RESPONSES TO  
NRC QUESTION  
ON THE  
DUANE ARNOLD ENERGY CENTER  
PUAR

PREPARED BY  
NUTECH ENGINEERS, INC.  
SAN JOSE, CALIFORNIA

PREPARED FOR  
IOWA ELECTRIC LIGHT AND POWER CO.

NRC QUESTION ON DUANE ARNOLD ENERGY CENTER

Figure 19 - 20" φ

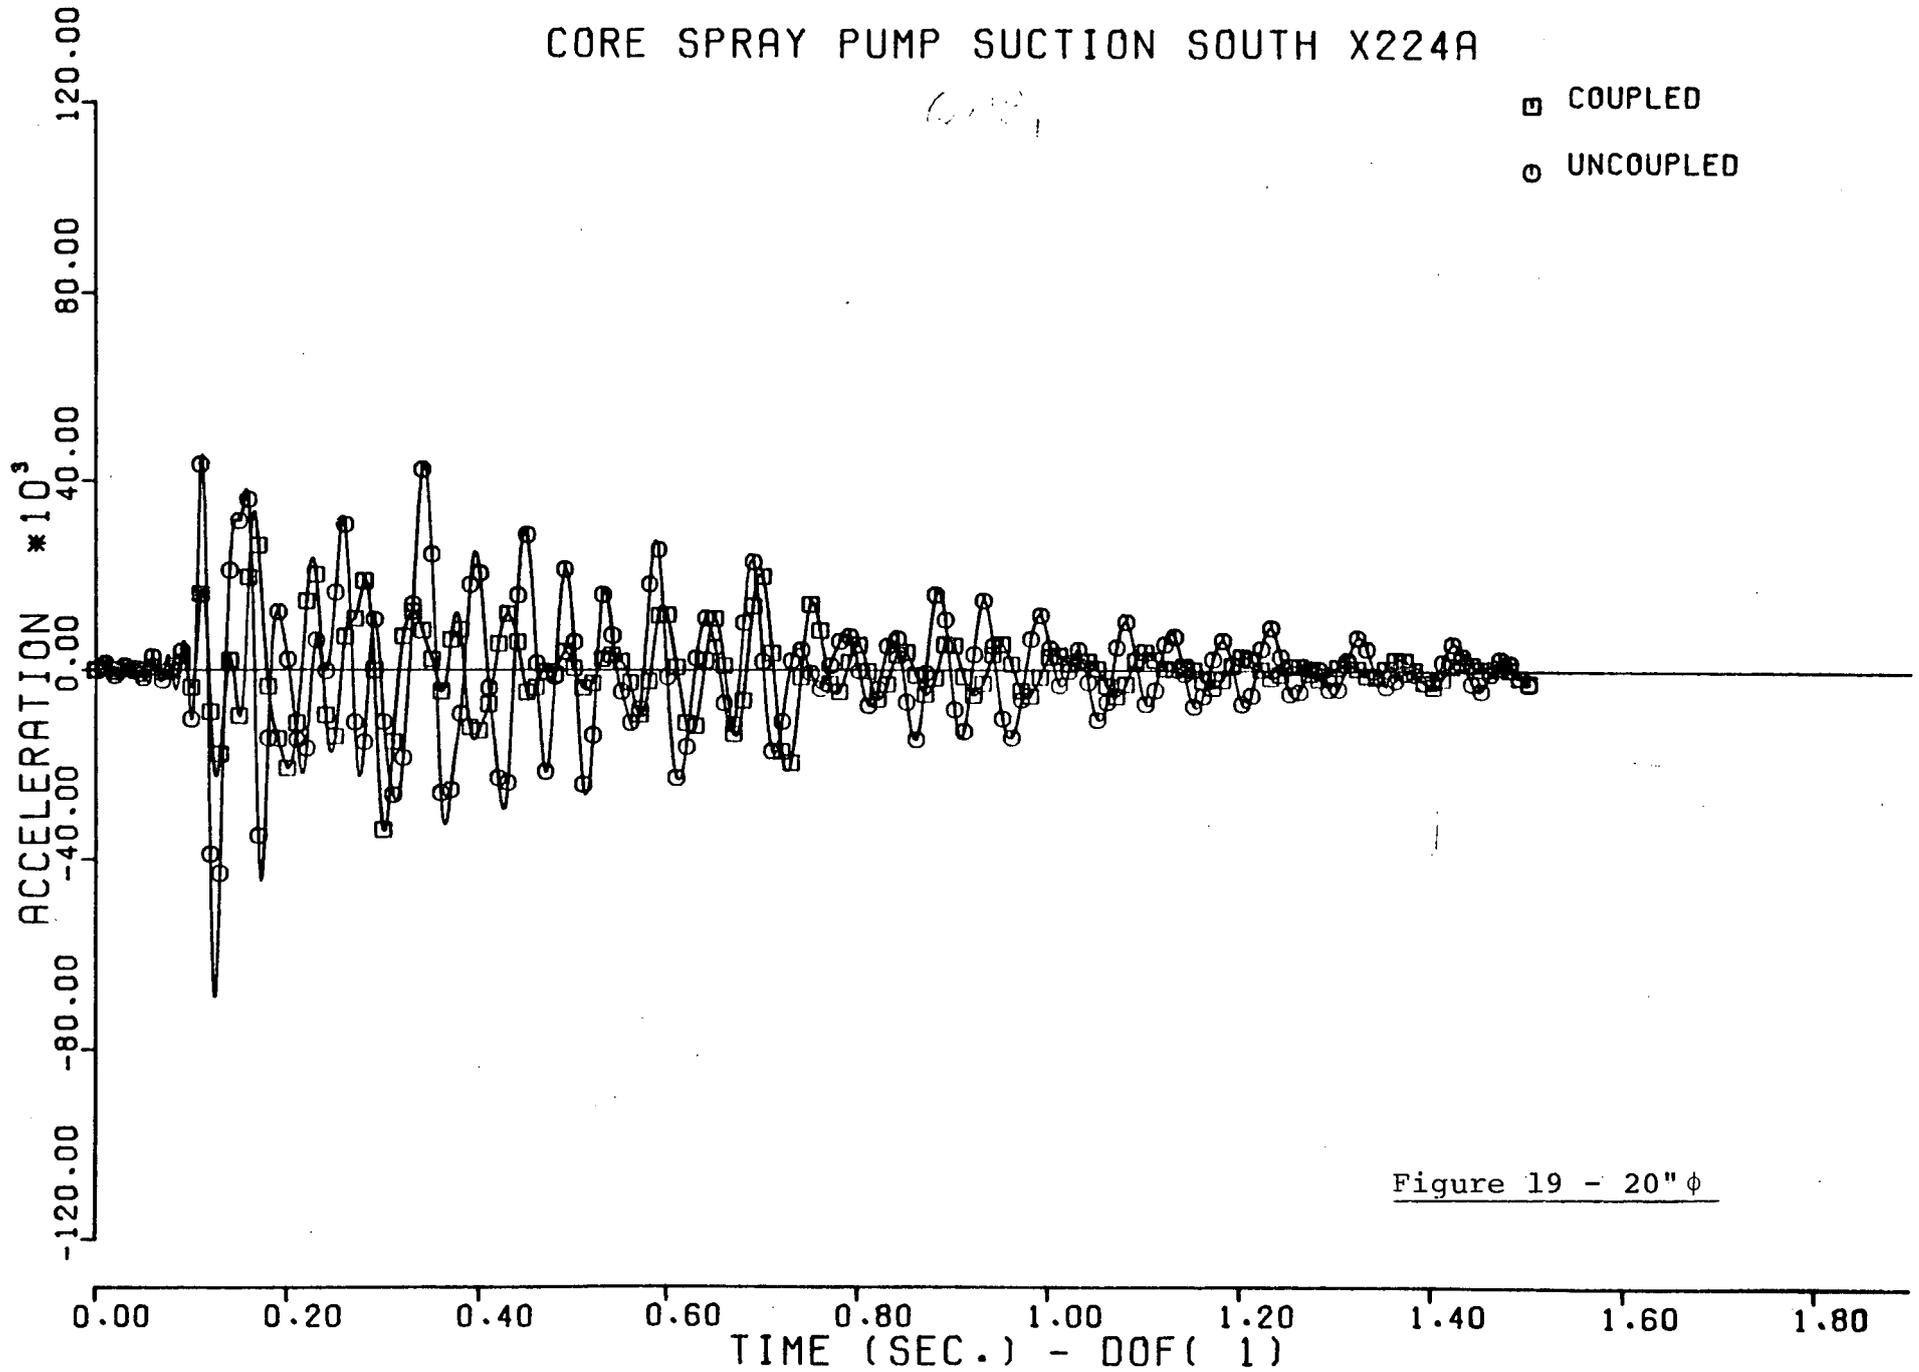
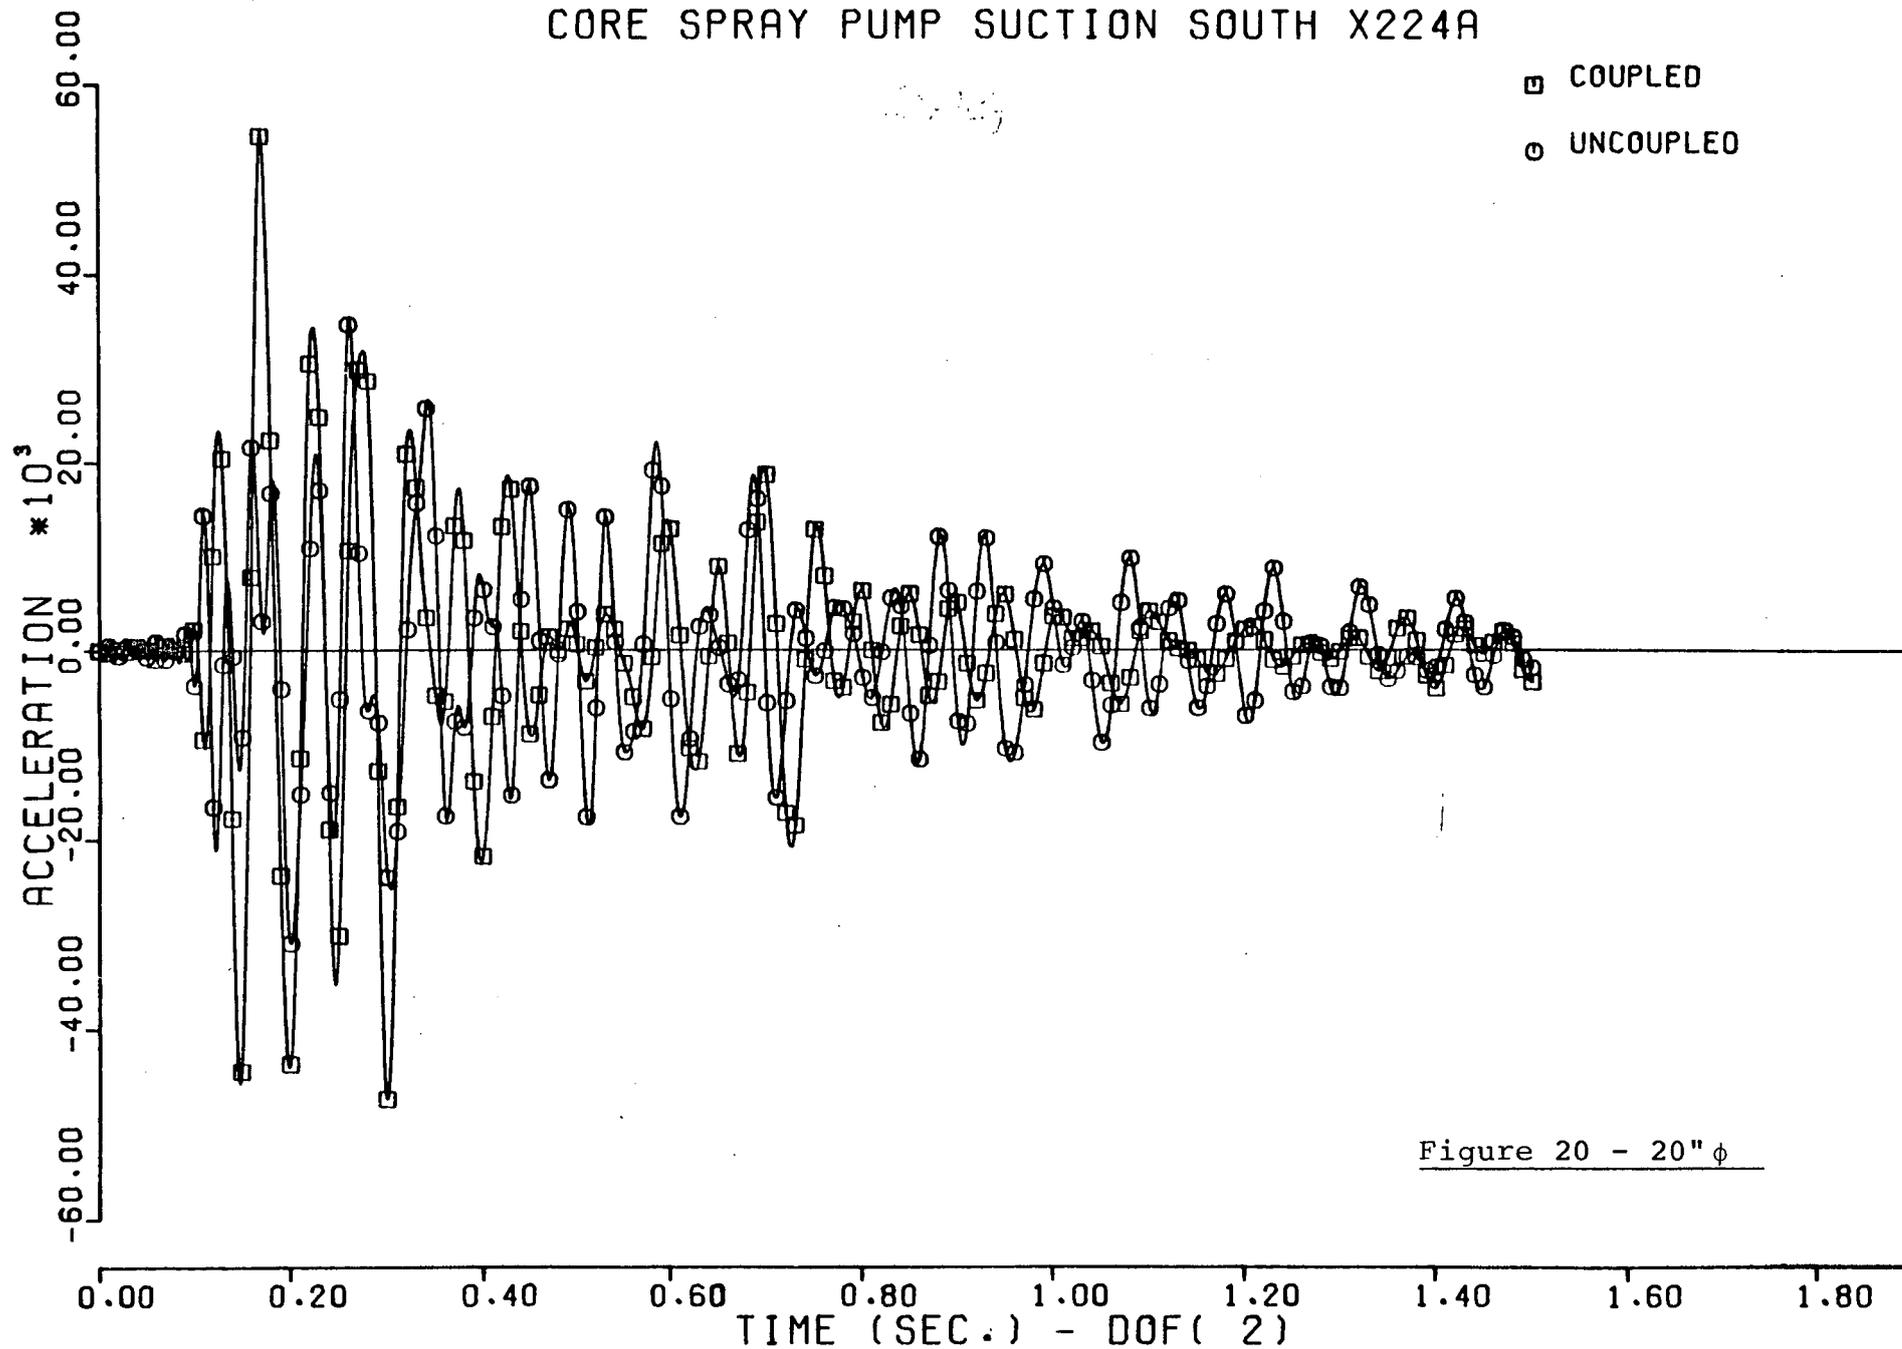
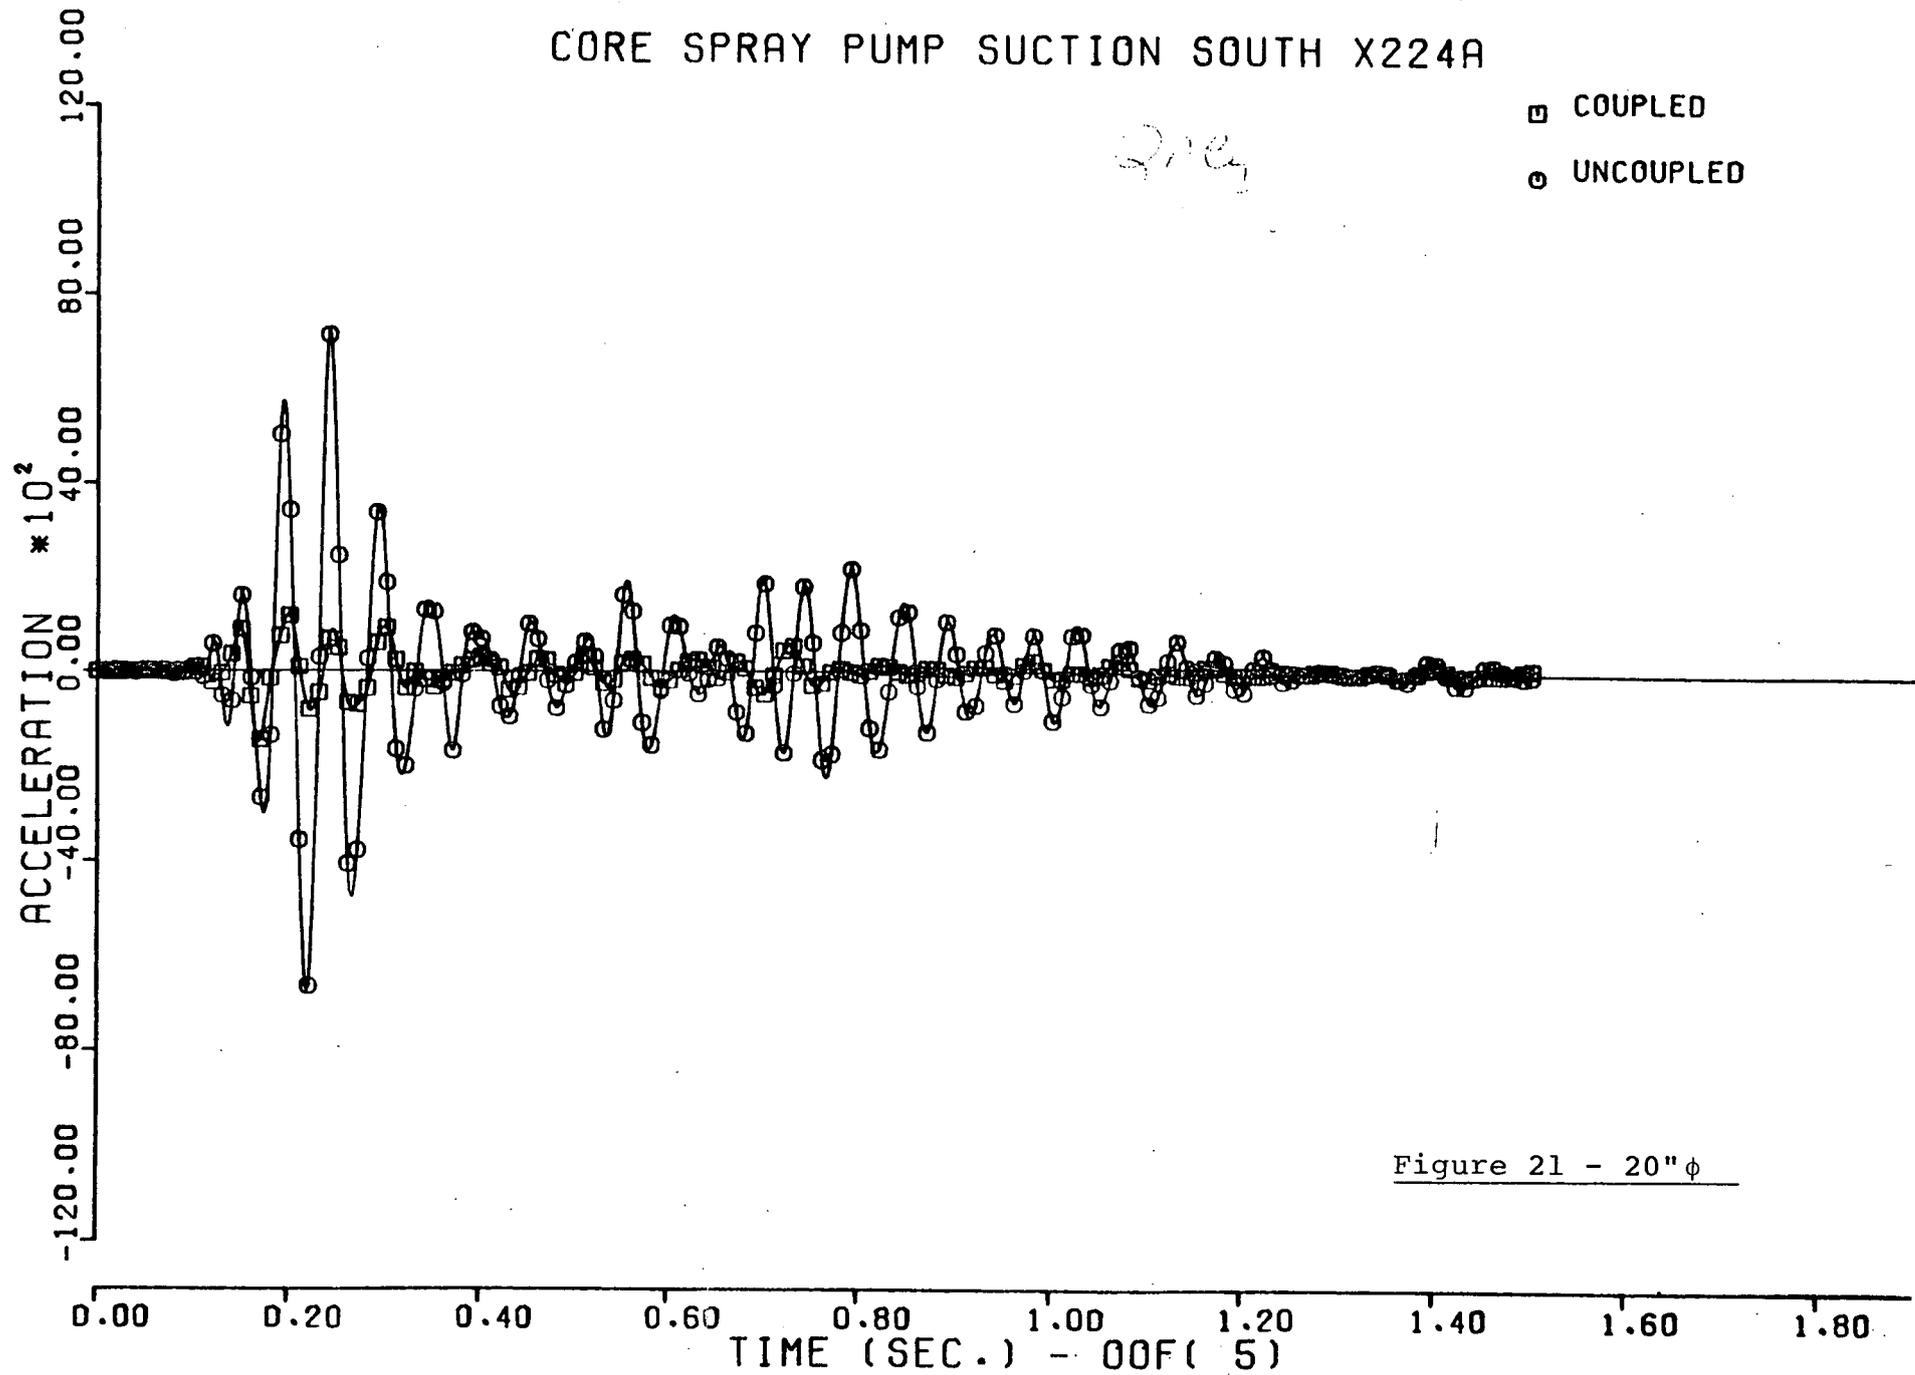
ITEM 3a: Provide the theoretical background in support of Section 2 of the report, and describe how the Section 6 guidelines (i.e., cut-off frequency and equations 2.27 and 2.28) have been used in the analysis.

To illustrate the effect of pipe size on coupling, four typical piping systems were examined and the coupled and uncoupled time histories plotted together. These time histories include both the smallest (2") and larger (20") systems analyzed. Listed below are the figure numbers and the corresponding line size.

Figure 4-8	2" diameter
9-13	4" diameter
14-18	6" diameter
19-21	20" diameter

These plots confirm the expected variation of coupling benefit with pipe size.
